**DEVELOPMENT REVIEW**

Property address or Location 3621 US Highway 1  
 Parcel ID #(s) 2434-601-0025-000-5  
 Project description Development of 1.51 acre site into warehouse/flex building with associated site improvements

**Re: Technical Review Committee (TRC) – Site Plan (Development and Design Review)  
Kieran Casey Warehouse/Flex Building – 2434-601-0025-000-5 – Response to TRC  
Comments**

**RE : Kieran Casey Site Plan – 3621 S. US Hwy. 1  
TRC No. 21-07000031**

FLORIDA  
KIERAN CASEY  
3621 US HIGHWAY 1  
SITE PLAN  
FORT PIERCE

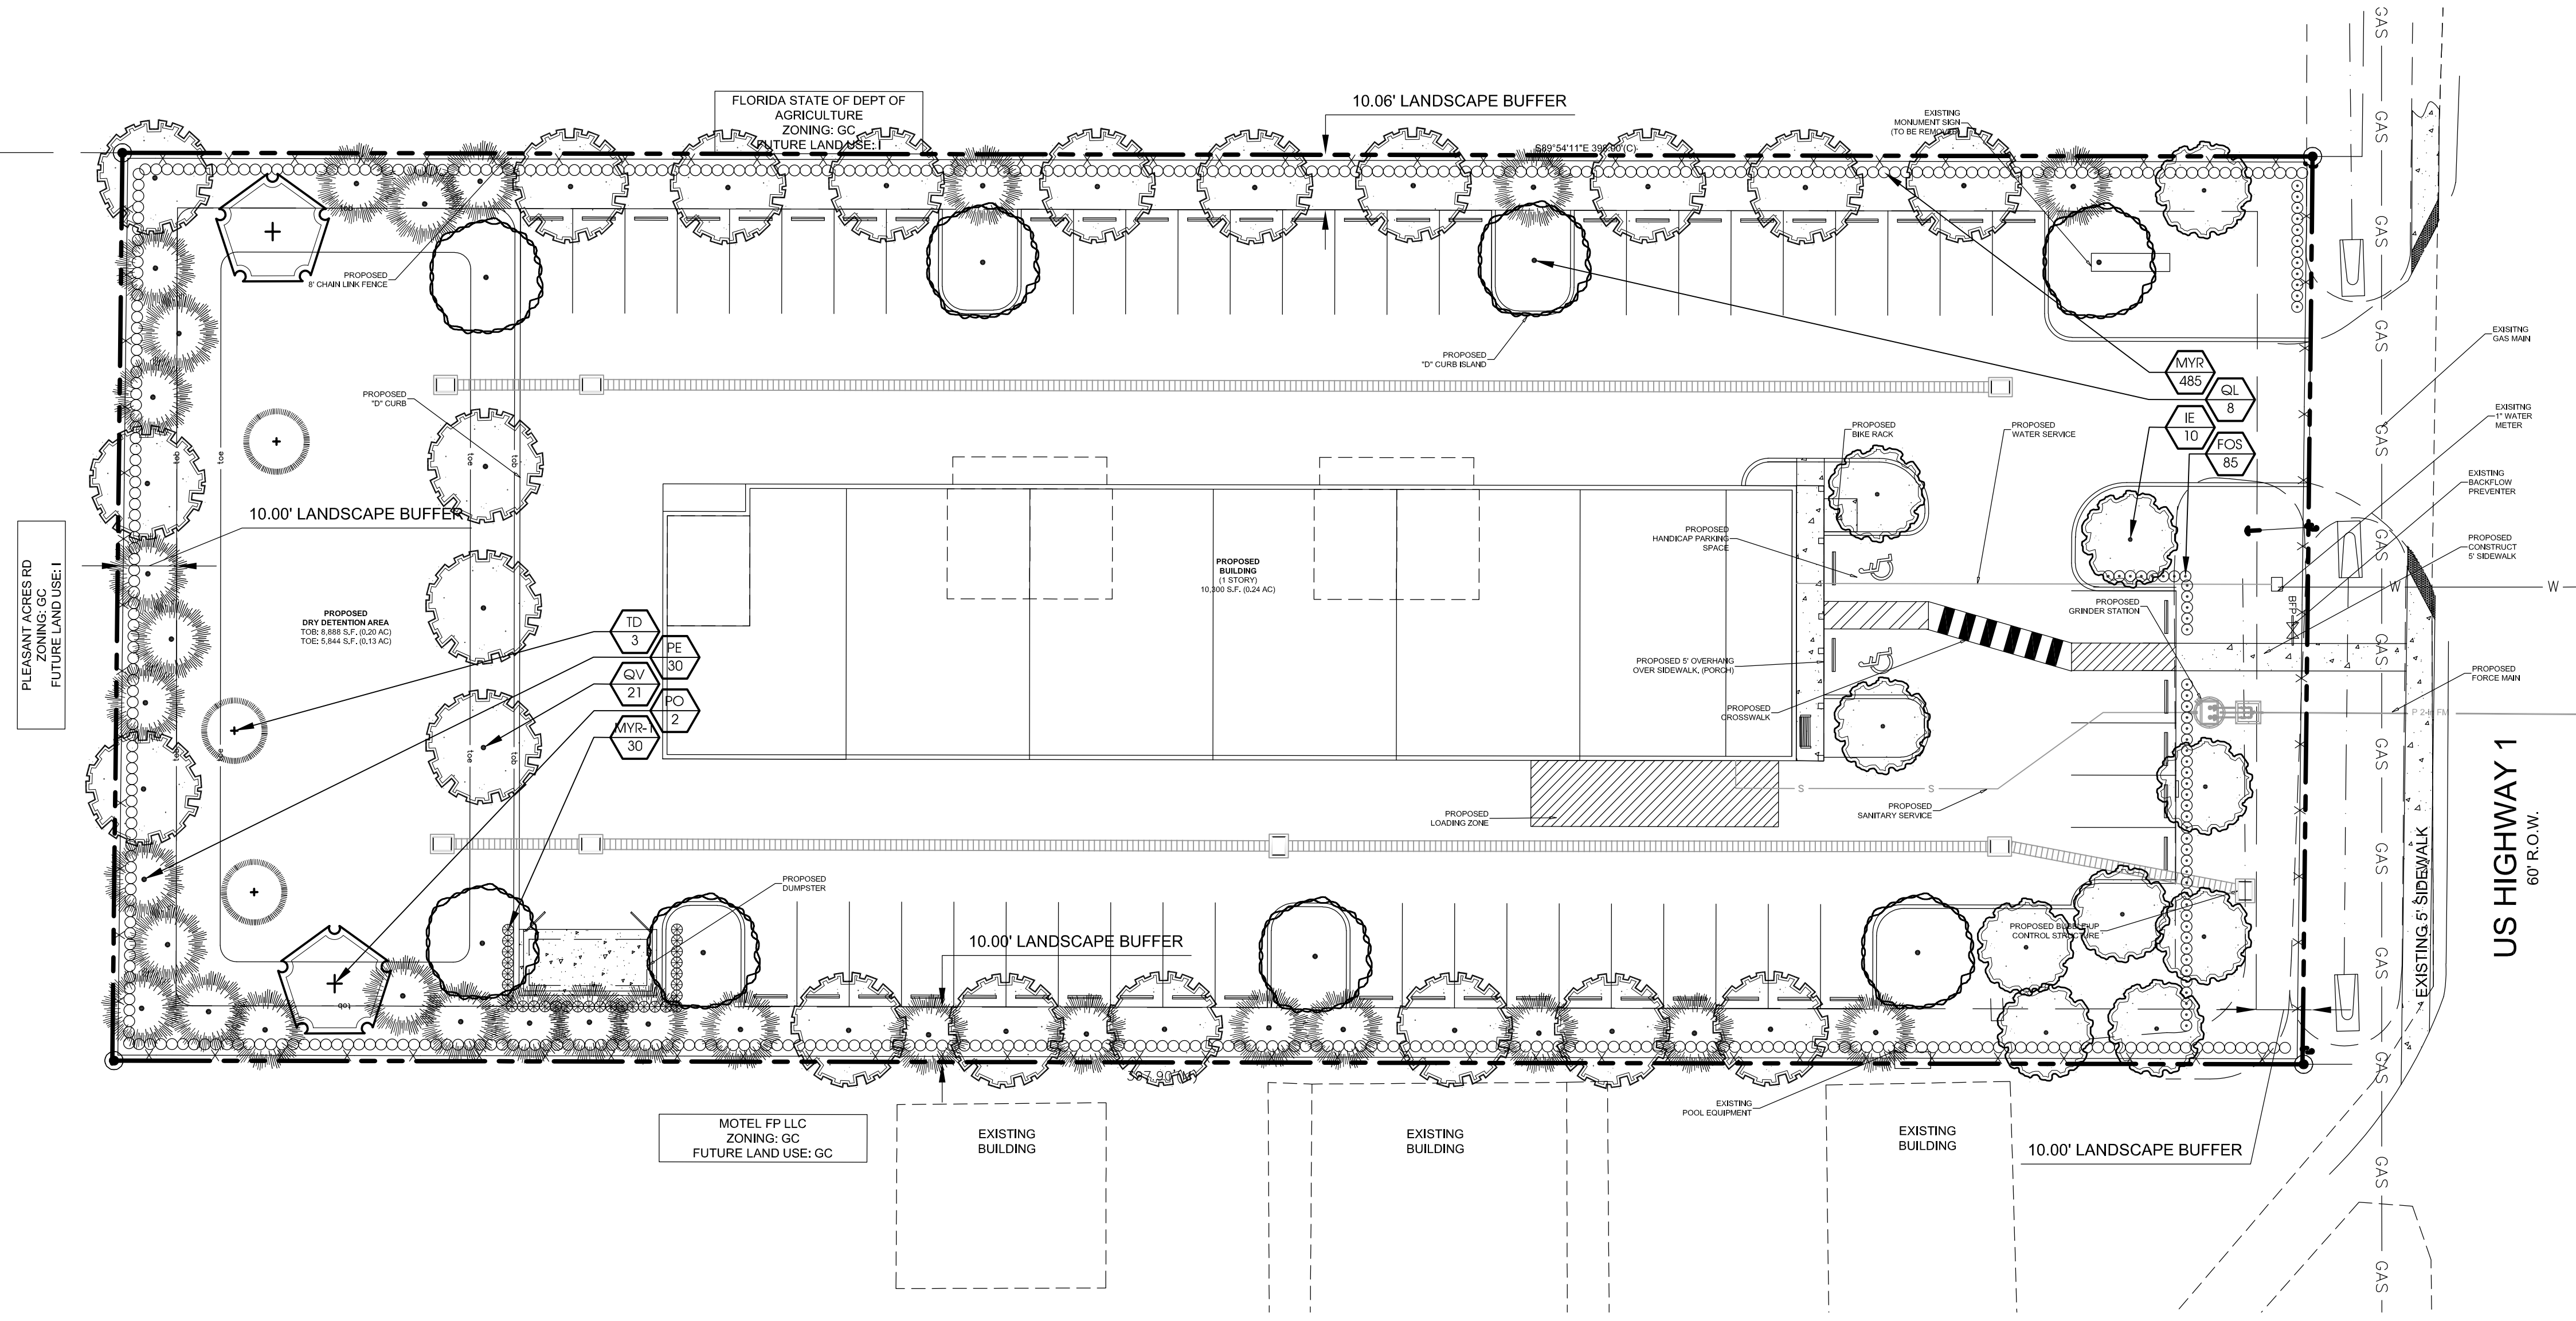
1. Please correct the following on the site plan data:
  - a. The building coverage maximum is 60% rather than 80%
  - b. The acreage breakdown adds up to 1.5 acres and the impervious area to 61.28%. Please correct
  - c. The parking spaces for retail – 1 space per 200 sf. the plan states 1 to 600 sf but the calculation was made from 1 to 200 as the required parking for retail is correct, just correct the formula.
  - d. Please correct that the uses are retail and warehouse not office as stated. Warehouse parking requirement is 1 space for 600 sf which equals 4 spaces not 7.

2. Please update Zoning Code information on the site plan to demonstrate compliance with the C-3 zoning district, as provided in the table below. The highlighted area is information that I calculated so please verify.

5. Fire hydrants (shall be) are provided for all buildings other than detached single one and two dwelling buildings IAW both of the following: 1) The maximum distance to a fire hydrant from the closest point to the building shall not exceed 400 feet. 2) The maximum distance between fire hydrants shall not exceed 500 ft. NFPA 1:18.5.3. Please provide fire flow calculations for fire hydrants.

***RESPONSE: Please see the updated Site Plan for corrections to the above noted comments. The proposed uses are retail and office. The data has been corrected on the site plan.***

**RESPONSE:** *The information from the above table has been added to the site plan.*

**RESPONSE: The closest fire hydrant is on the east side of US1 approximately 105' from the property line and approximately 225' from the closest point to the building. A fire hydrant is proposed adjacent to US1 in the front of the property. Please see updated site plan.**
